BURLINGTON DEVELOPMENT REVIEW BOARD

Tuesday October 2nd, 2018, 5:00 PM

BURLINGTON DEVELOPMENT REVIEW BOARD Tuesday October 2nd, 2018, 5:00 PM Contois Auditorium, City Hall, 149 Church St, Burlington, VT AGENDA

PHASE
CONCEPT
SITE PLAN

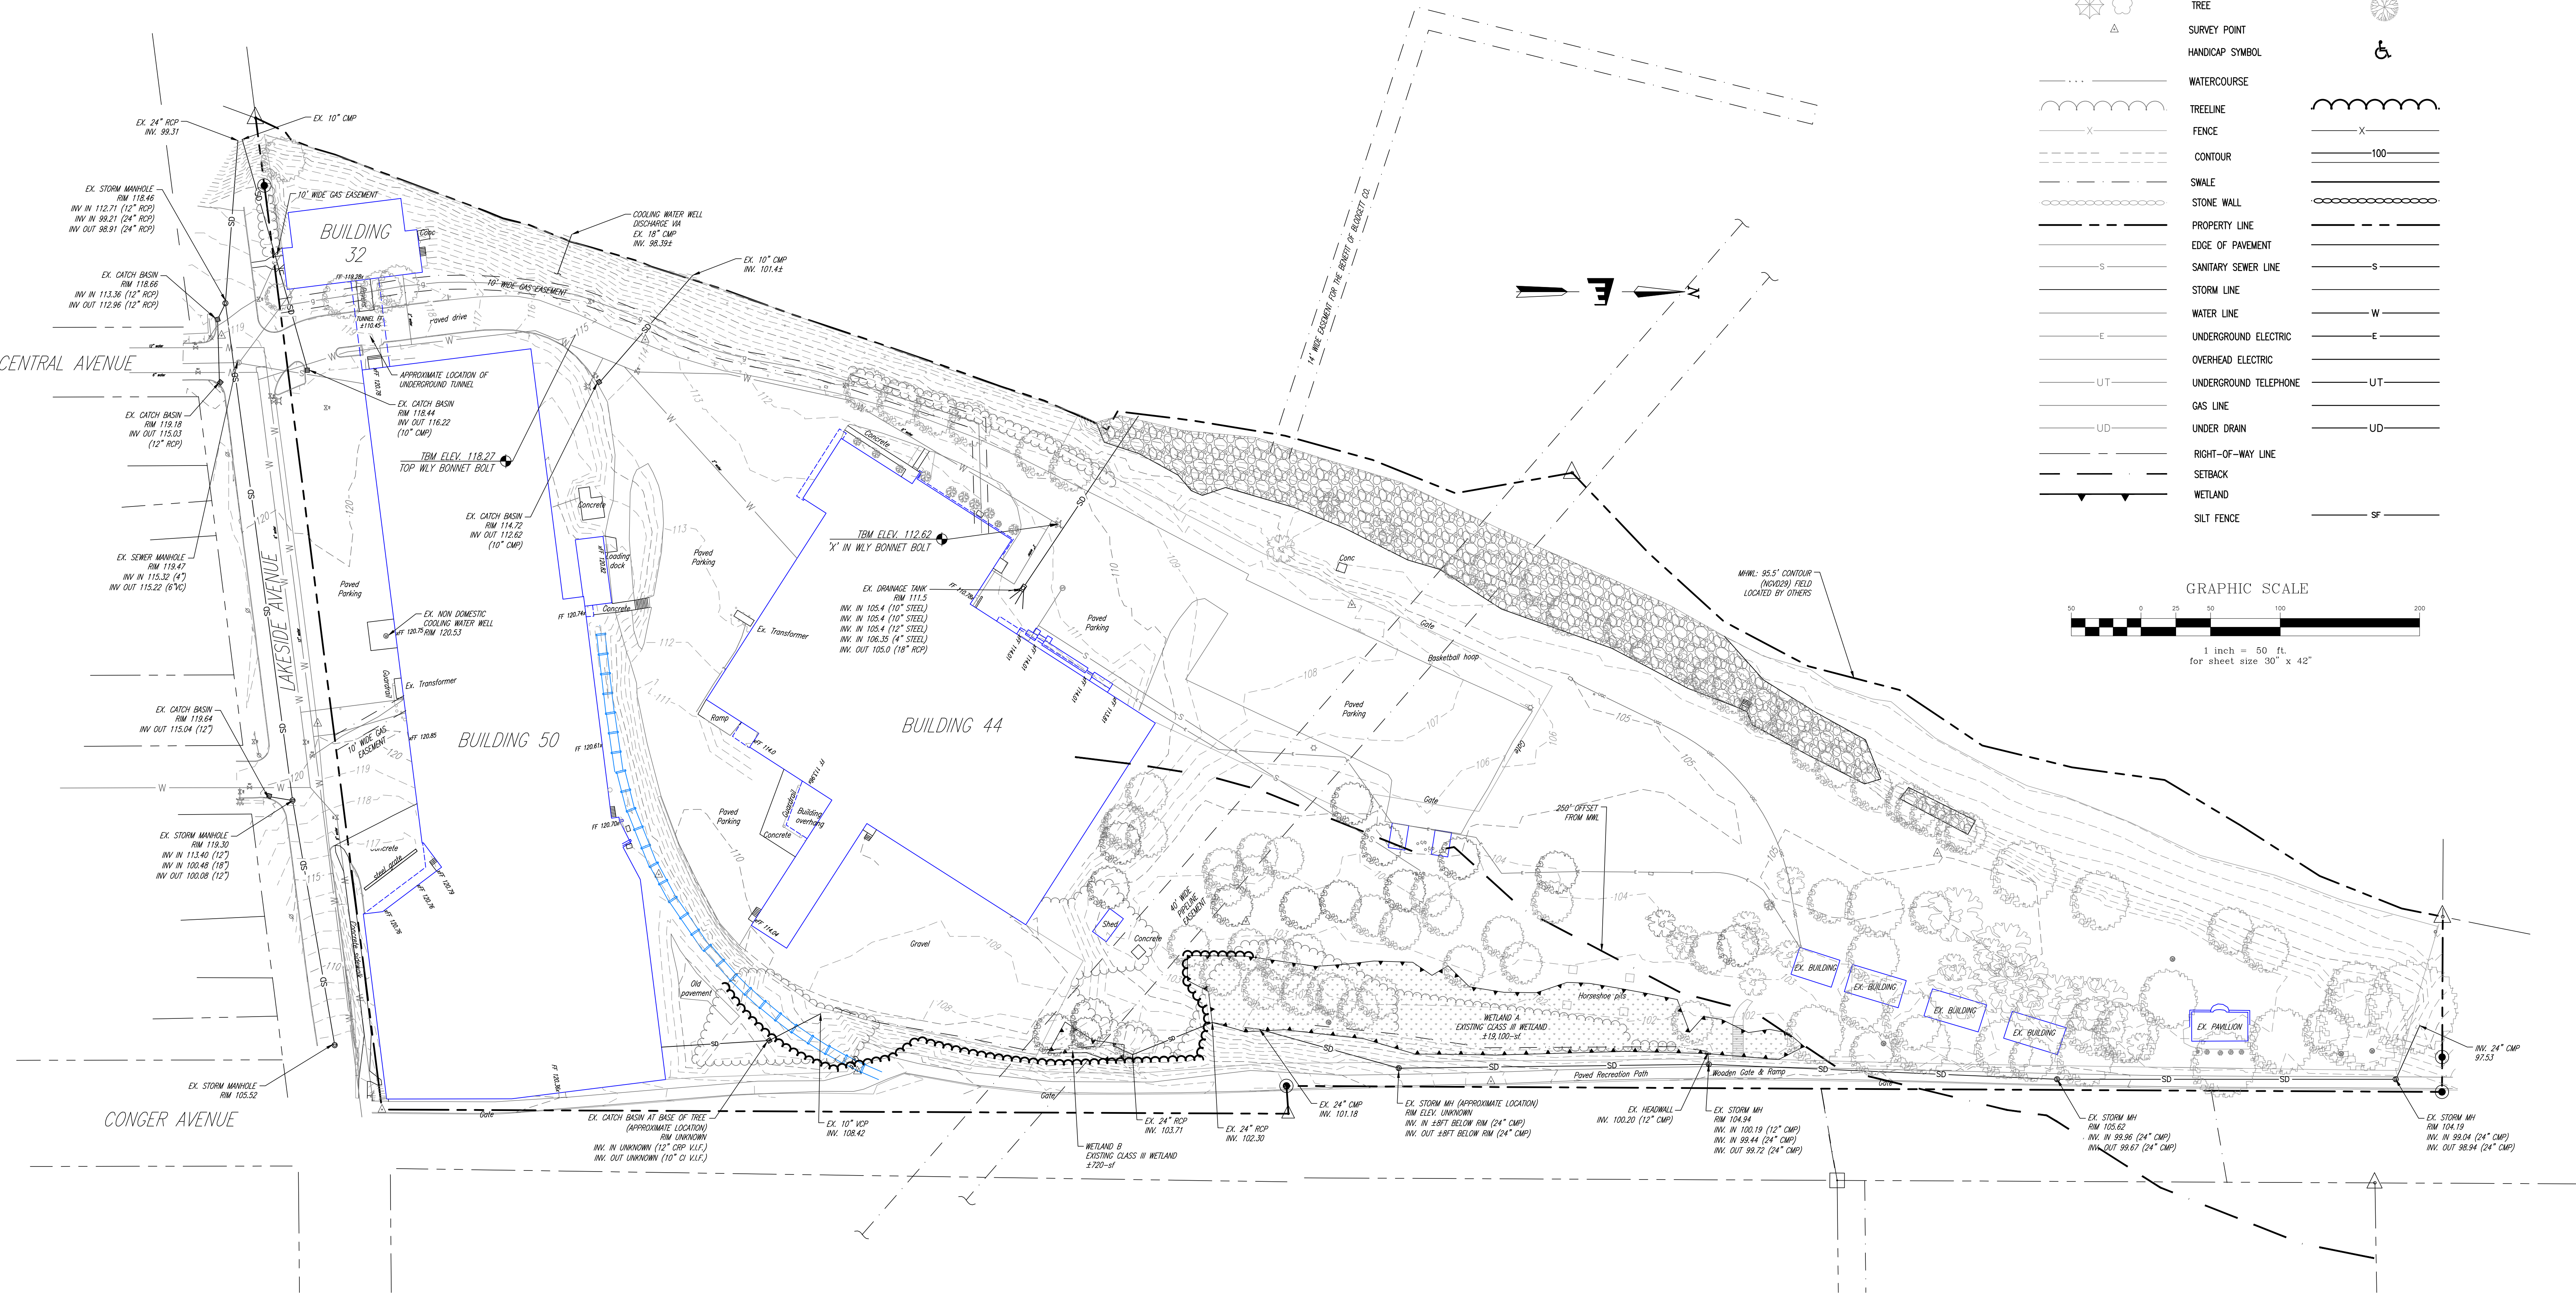
Curbing is evident along portions of the parking and circulation areas. Much of the parking is without curbing. Continuous curbing is not required; however, this criterion requires curb stops or similar items at the edges of parking areas in order to prevent parking creep. The site plans must be revised accordingly.

Existing and proposed ground-mounted mechanical equipment will be enclosed with metal panel screening. Similar screening will be provided for trash and recycling facilities onsite. The site plan notes a trash and recycling enclosure along building 50's primary façade – facing Lakeside

Several outdoor bike rack locations are depicted on the site plan; however, additional details are lacking. No total number of short versus long term (outdoor versus indoor/sheltered) bike parking has been provided, nor have any details been provided as to what type of bike racks or indoor/sheltered storage will be provided. As with car parking, an articulation of how much space will be occupied by which uses is needed. Without that, compliance cannot be determined. **(No finding possible)**

- c. Obtain final approval of the EPSC and stormwater management plans from the city's Stormwater Program;
 - d. Provide loading area details;
 - e. Relocate the trash/recycling enclosure from the south side of building 50 to another location behind this, or other, building(s) onsite;

- f. Provide walkways along both sides of the landscaping island centered within the northern parking area; and,
 - g. Provision of the required Administrative Officer's endorsement block on the boundary survey.

Affirmative finding for number and height. Area move to greater conformity.

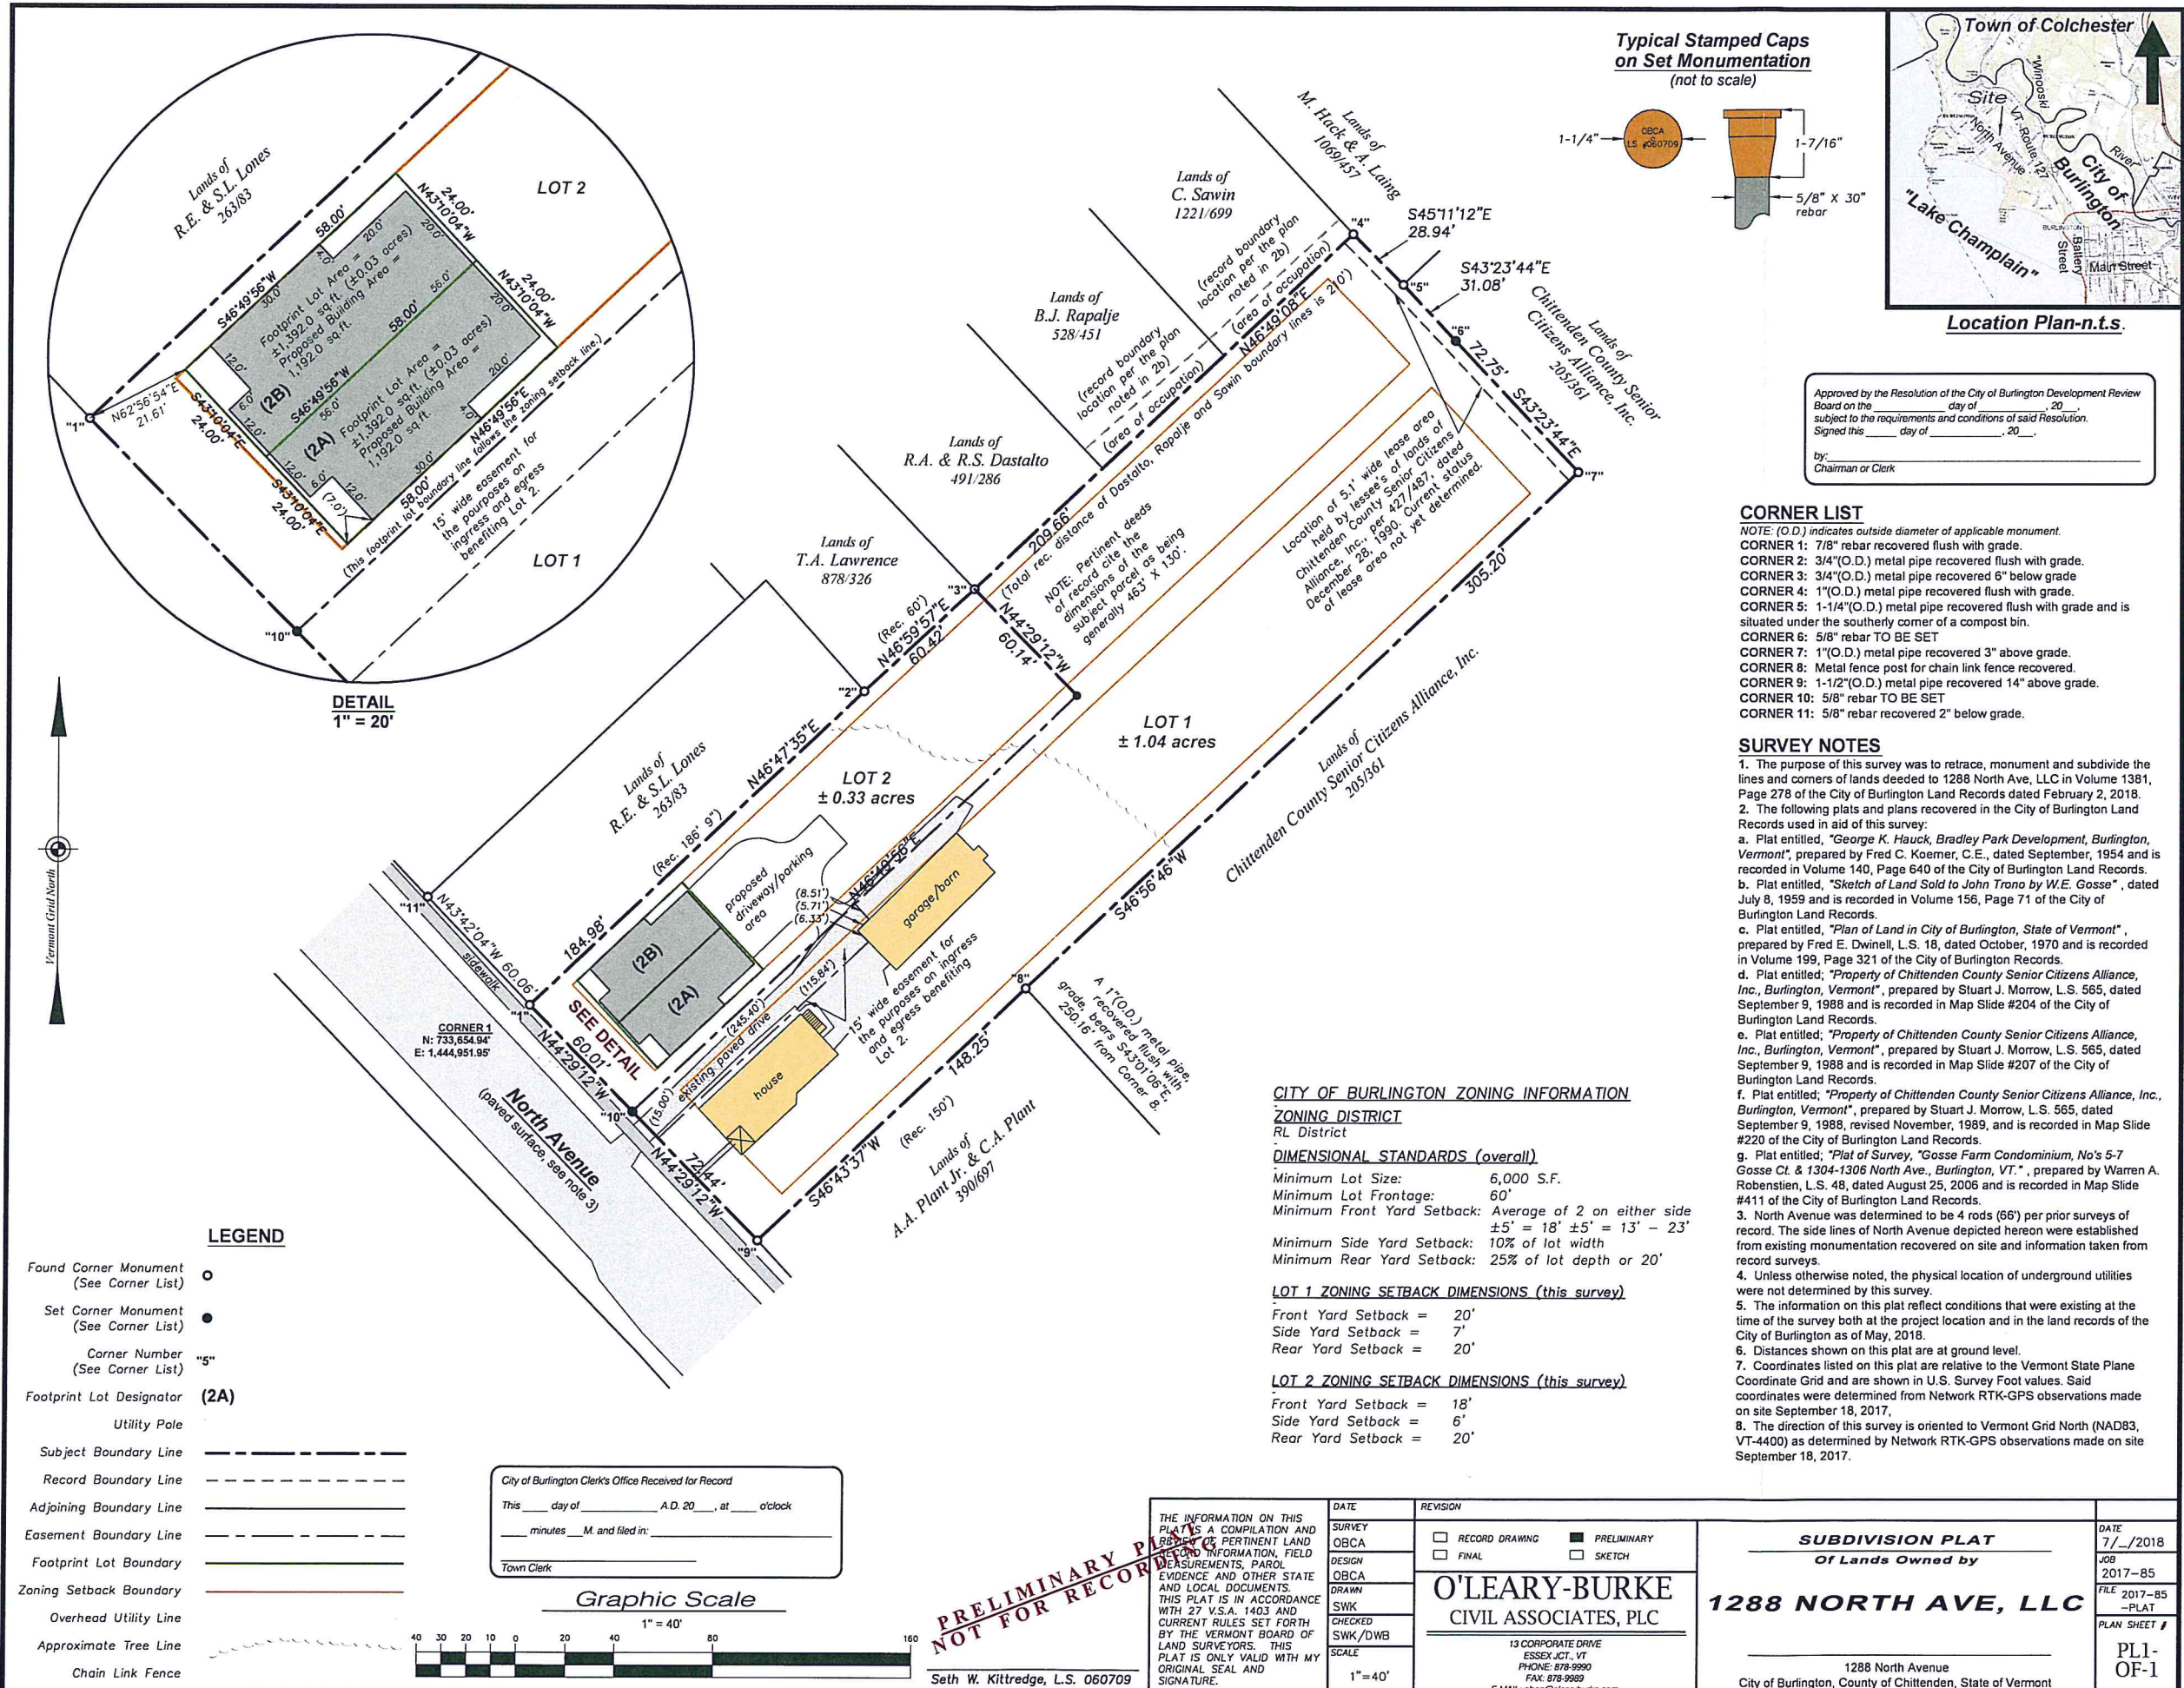
- Lot #2-Sheet PL1-OF-1 the plan set indicates the proposed lot will only have 3 corners established, corner points "10", "1", and "3". The proposed parcel should have monumenting on all four corners,
- Driveway easement for Lot #2 needs to be noted in the deeds for Lot #1 and Lot #2.
